SAFETY RECALL NOTICE

SAFETY RECALL CAMPAIGN #13E-042

Sportworks Northwest, Inc. ("Sportworks") has decided that a defect which relates to motor vehicle safety exists in its Apex 3™ bicycle racks **manufactured prior to April 8, 2013**.

FIGURE 1: APEX REVISION SCHEMATIC

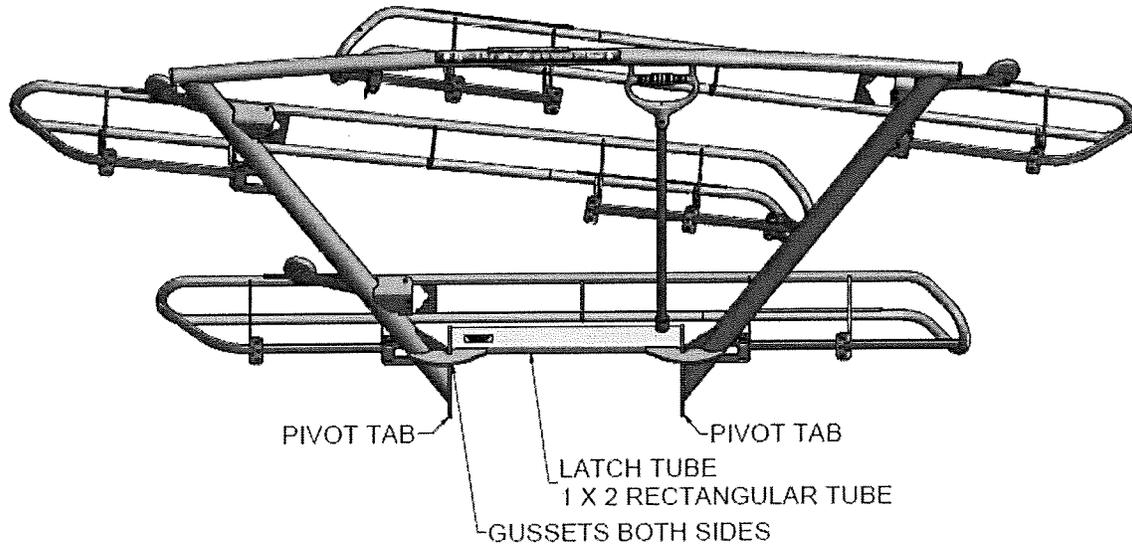
The possibility exists that cracks may develop where the latch tube is welded to the two pivot tabs connected to the rack frame. Over time, the cracks may lead to the separation of the latch tube from the pivot tabs, causing the latch tube and latch handle to fall from the rack, resulting in potential road hazards increasing the risk of crash.

NOTE: Apex 3™ bicycle racks manufactured after April 8, 2013 have a larger rectangular latch tube and gussets supporting the weld between the new latch tube and round frame tubing and are not included in this recall (see Figure 1 attached).

Please immediately notify all of your customers who have purchased the recalled Apex 3™ units to contact Sportworks on or after September 1, 2013 to request a free replacement Apex 3™ frame. We have enclosed an owner safety recall notification letter and envelopes which you may use to communicate this notice to your customers.
